Access Compliance Report

Public Rights-of-Way

(Curb Ramps)

Intersection ID: 54218	Main Street: GOLF_LINKS_DR	Cross Street: SANDY_ROCK_PL	Location: NE
ADA ID: 2CD4B8372446	Ramp Type: Perp	Initial Pass/Fail: Fail	Overall Compliance: No
Severity Score: 12.5			
Codes/Mitigation Info/Possible Solution		Field Measurements/Component Compliance

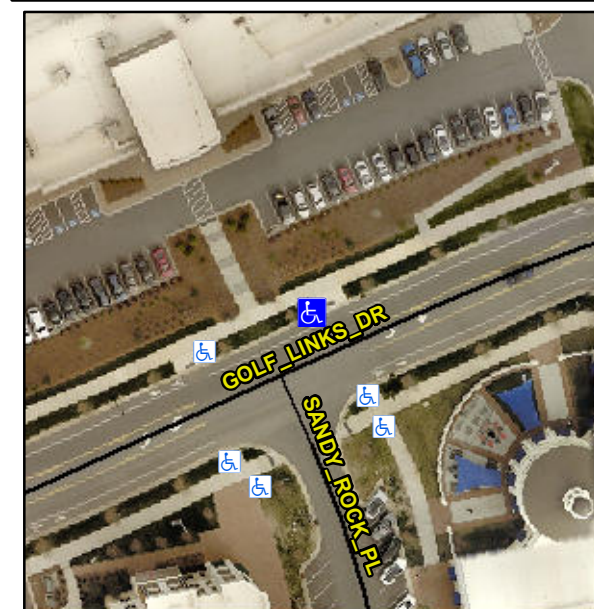
Not Found, R304.2.2

Compliance	Description	Data	Compliance	Description	Data
N/A	Ramp Length (in)	96.0	No	Ramp Slope (%)	8.6
Yes	Ramp Width (in)	60.0	Yes	Ramp XSlope (%)	1.6
N/A	Flare Type LT	N/A	N/A	Flare Type RT	N/A
N/A	Flare Slope LT (%)	N/A	N/A	Flare Slope RT (%)	N/A
N/A	Flare Traversable LT?	N/A	N/A	Flare Traversable RT?	N/A
N/A	Landing Length (in)	N/A	N/A	DWS Provided?	N/A
N/A	Landing Width (in)	N/A	N/A	DWS Contrast?	N/A
N/A	Landing Slope (%)	N/A	N/A	DWS Length (in)	N/A
N/A	Landing X Slope (%)	N/A	N/A	DWS Full Width?	N/A
N/A	Landing Curb? (Y/N)	N/A	N/A	DWS Offset (in)	N/A
N/A	Shared Landing?	N/A			
N/A	Gutter Ponding?	N/A	N/A	Gutter Slope (%)	N/A
N/A	Gutter Lip Ht (in)	N/A	N/A	Gutter X Slope (%)	N/A
N/A	Painted X Walk1?	No	N/A	Painted X Walk2?	N/A
	X Walk 1 Direction	To SE		X Walk 2 Direction	N/A
N/A	X Walk 1 Width (in)	N/A	N/A	X Walk 2 Width (in)	N/A
	X Walk 1 Slope (%)	6.5		X Walk 2 Slope (%)	N/A
	X Walk 1 X Slope (%)	1.5		X Walk 2 X Slope (%)	N/A

Remove & Replace Entire Ramp.
